Access Compliance Report

Public Rights-of-Way

(Curb Ramps)

Intersection ID: 49102	Main Street: PROSPERITY_CROSSING_DR	Cross Street: BENFIELD_RD	Location: E
ADA ID: 579D649FC41C	Ramp Type: Directional1	Initial Pass/Fail: Pass	Overall Compliance: No
Severity Score: 5.25			
Codes/Mitigation Info/Possible Solution		Field Measurements/Component Compliance

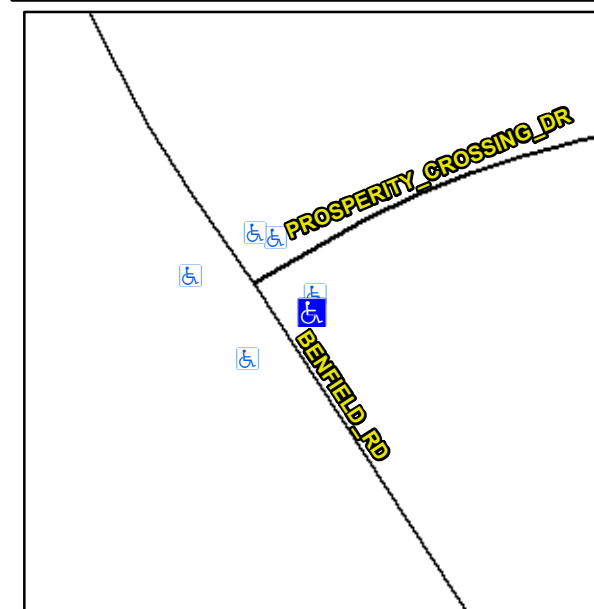
Remove & Replace Gutter.

R304.5.4
